### Draft Regulation

Building Act  
(chapter B-1.1)

#### **Construction Code — Chapter I.1, Energy Efficiency of Buildings — Amendment**

## Regulation to amend the Construction Code

**Figure A-3.2.2.2.(5)**

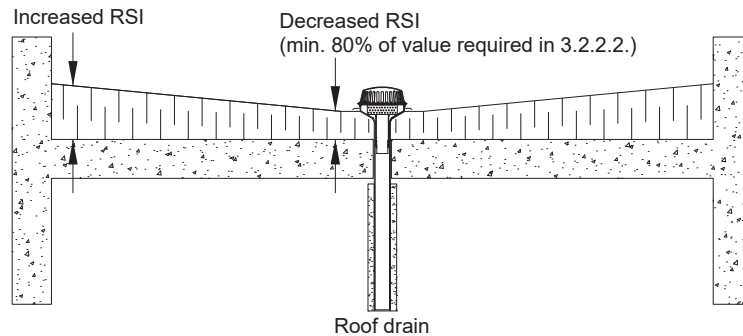
**“A-3.2.2.2.(5) Effective Thermal Resistance of a Flat Roof.** Sentence 3.2.2.2.(5) allows the reduction of the effective thermal resistance around the drain of a roof provided that the dimension of the roof and the slope are sufficient to offset heat losses incurred in the portion that does not comply with the requirements of Article 3.2.2.2. Figure A-3.2.2.2.(5) illustrates the application.

**Figure A-3.2.3.3.-A**

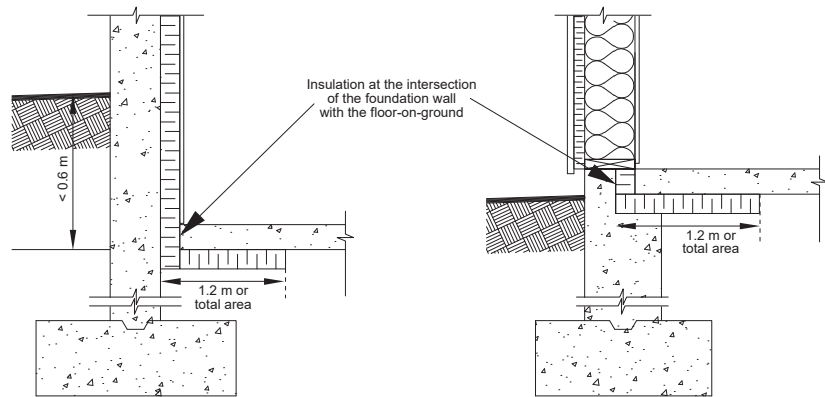
<p>Add the following Note:</p> <p><b>“A-3.2.3.1.(5) Slab-on-Ground.</b> Sentence 3.2.3.1.(5) requires that the vertical section of a slab-on-ground be insulated over its entire height just like a wall in contact with the ground in accordance with the requirements of Sentence 3.2.3.1.(1), as shown in Figure A-3.2.3.1.(5).</p>  <p><b>Figure A-3.2.3.1.(5)</b> <b>Vertical insulation of a slab-on-ground according to Sentence 3.2.3.1.(5)”. </b></p>
<p><b>A-3.2.3.2.(1)</b></p>	<p>Replace the word “grade” wherever it appears by “ground level”;</p> <hr/> <p>Strike out the last sentence of the Note.</p>
<p><b>A-3.2.3.3.</b></p>	<p>Replace the Note by the following:</p> <p><b>“A-3.2.3.3. Floors in Contact with the Ground.</b> Article 3.2.3.3. is also intended to include “floors” of heated or cooled crawl spaces even when there is no actual constructed “floor”.</p> <p>The value of the most astringent thermal resistance determines that of the insulation material to be installed over the entire floor surface where the ground level adjacent to a floor-on-ground is variable according to the faces of an immovable. In the case of a building whose floor-on-ground is constructed in tiers, it is possible to apply the requirements of Article 3.2.3.3. to each tier. Consideration should be given to insulating the entire floor at sites where the soil is highly conductive or where there is a permanently high water table. Figures A-3.2.3.3.-A, A-3.2.3.3.-B, A-3.2.3.3.-C and A-3.2.3.3.-D illustrate the requirements in insulation for various types of floors-on-ground where these are less than 0.6 m below grade.</p>

**Figure A-4.1.1.3.(1)**  
**Code compliance paths for lighting”.**

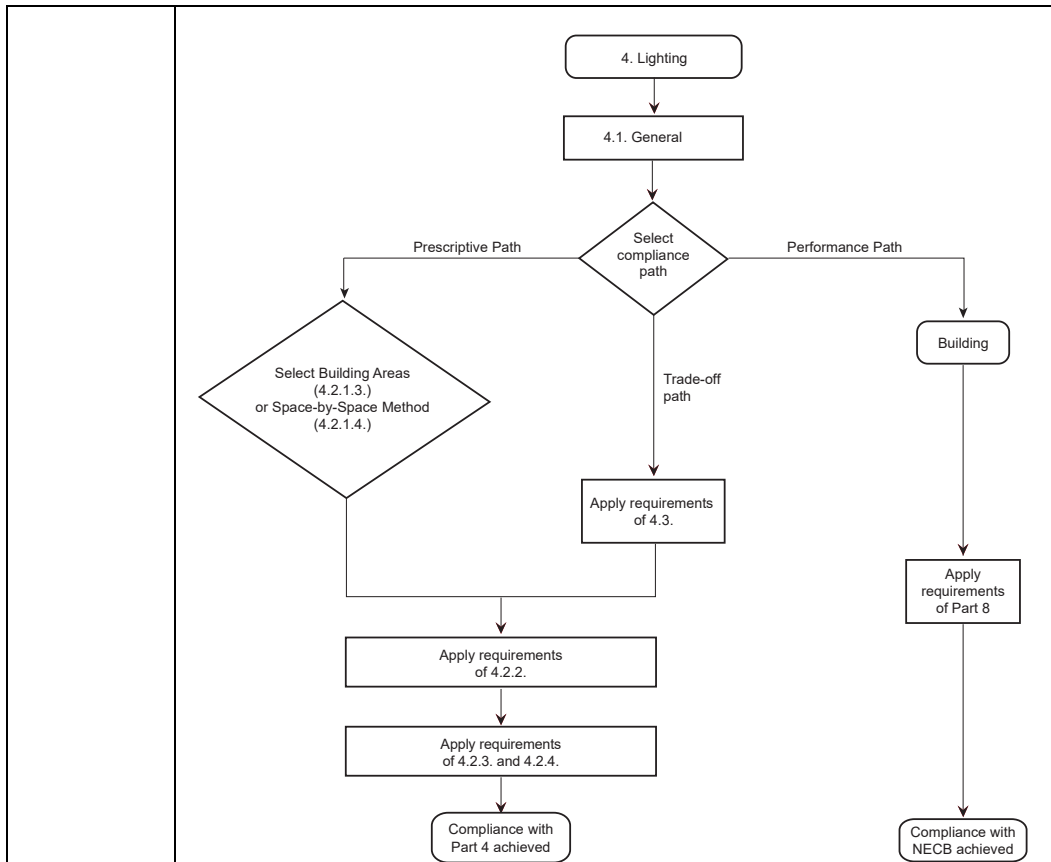
<b>Division B</b> <b>Part 4</b> <b>Schedule A</b>	
	<p>Add the following Note:</p> <p><b>“A-4.1.1.2.(2)(b) Application to Dwelling Units.</b> The interior lighting of dwelling units need not comply with the requirement of Part 4. The interior lighting of common parts of a building with dwelling units is not covered by the exclusion of that Clause and shall comply with the requirements of Part 4.”.</p>
<b>A-</b> <b>4.1.1.2.(2)(c)</b>	<p>Strike out the Note.</p>
<b>A-4.1.1.3.(1)</b>	<p>Replace the Note by the following:</p> <p><b>“A-4.1.1.3.(1) Compliance.</b> The flow chart in Figure A-4.1.1.3.(1) illustrates the process for all three paths of compliance applicable to Part 4.</p>

**Figure A-5.2.2.9.-A**

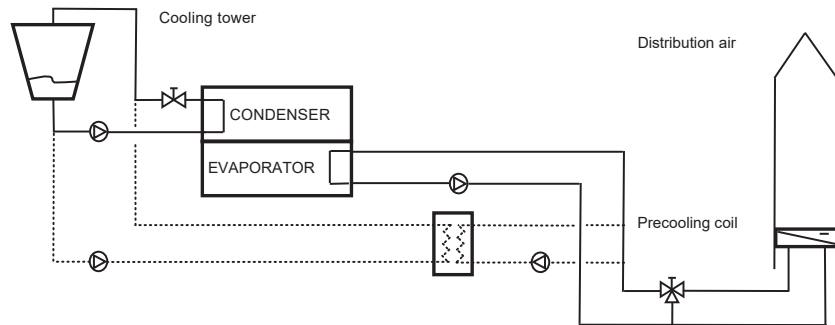
- evaporation cooling, also called “water precooling,” such as that shown in Figure A-5.2.2.9.-A, and
- sensible heat transfer cooling, also called “air precooling,” such as that shown in Figure A-5.2.2.9.-B.

**Figure A-5.2.3.1.**

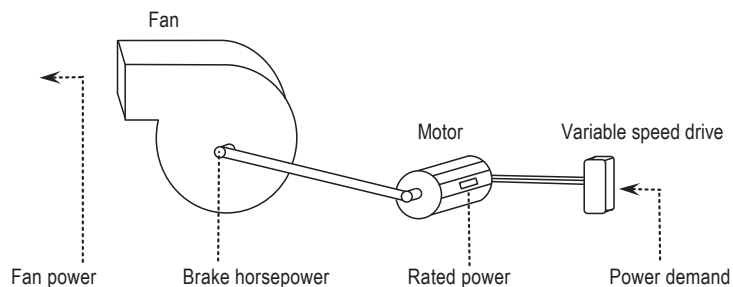
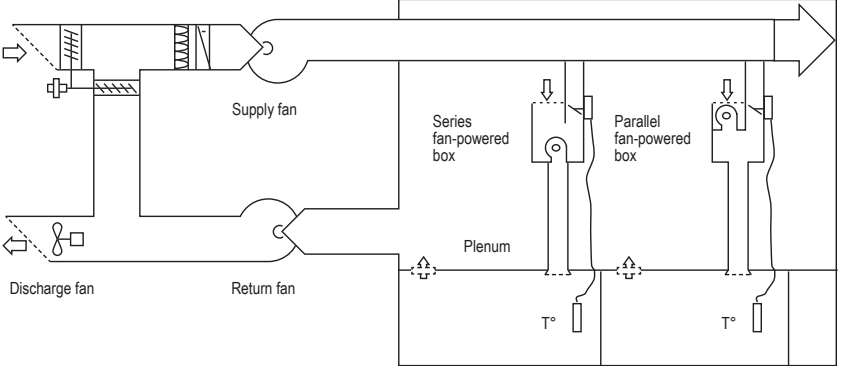
Figure A-5.2.3.1. shows the various locations where the capacity of a fan can be measured.

**Figure A-6.2.3.1.(5) and 6.2.3.2.(1)**

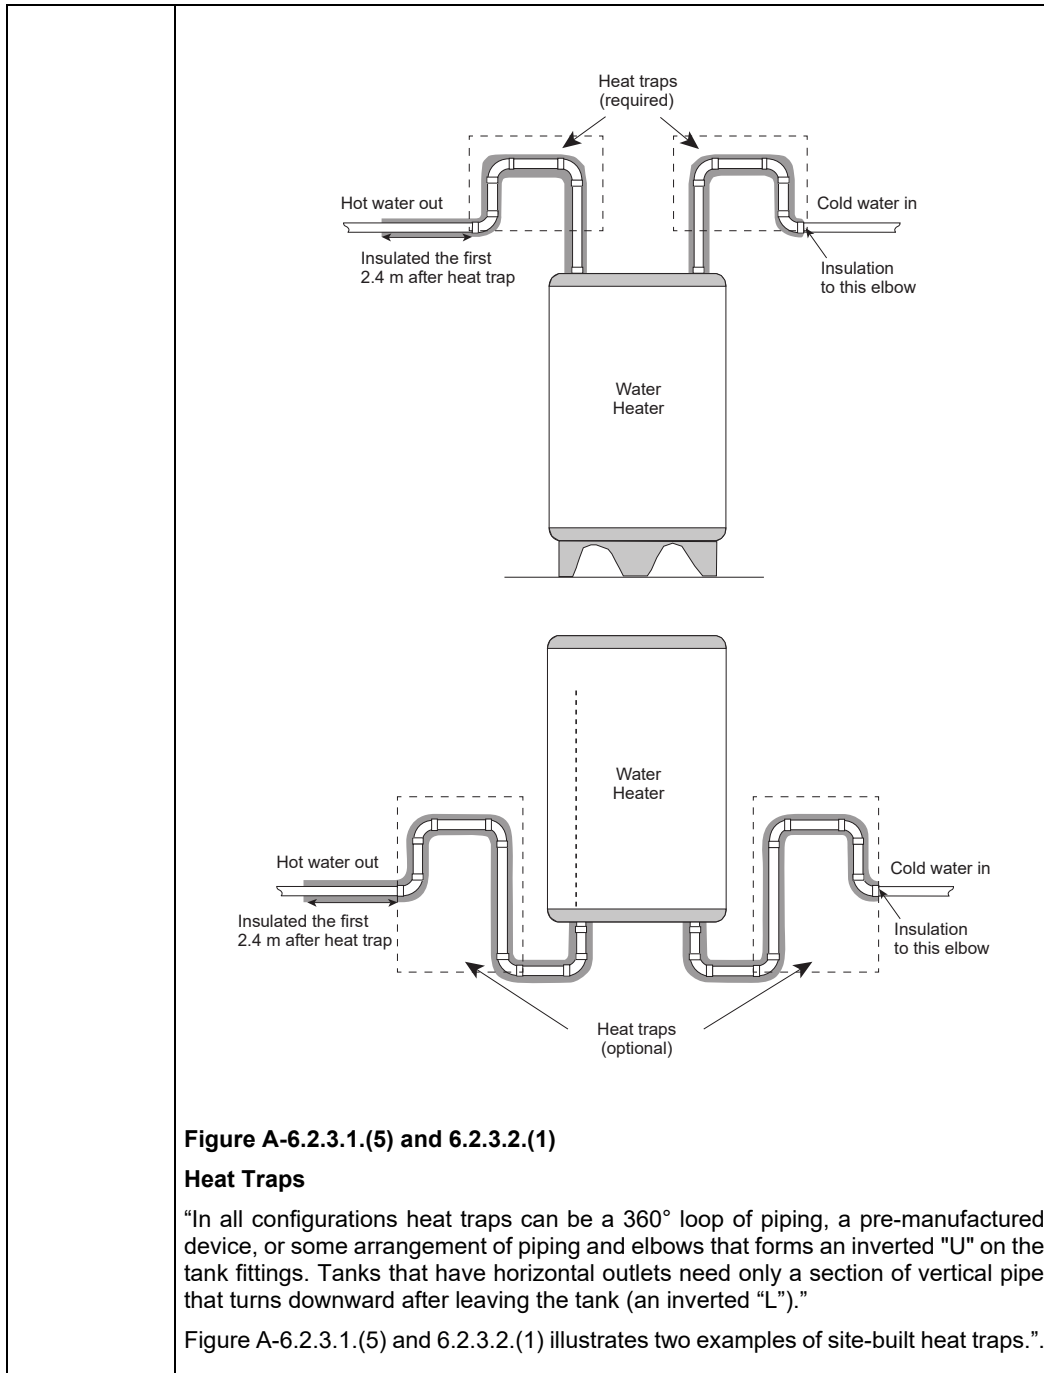
<b>A-6.2.3.1.(1)</b>	Strike out the Note.
	Add the following Note: <b>“A-6.2.3.1.(5) and 6.2.3.2.(1) Heat Traps.</b> ASHRAE/IES 90.1, “User’s Manual,” defines a heat trap as follows: “A heat trap is a device or arrangement of piping that keeps the buoyant hot water from circulating through a piping distribution system through natural convection. By restricting the flow from the storage tank, standby heat loss is minimized.”

Figure A-6.2.3.1.(5) and 6.2.3.2.(1) illustrates two examples of site-built heat traps."
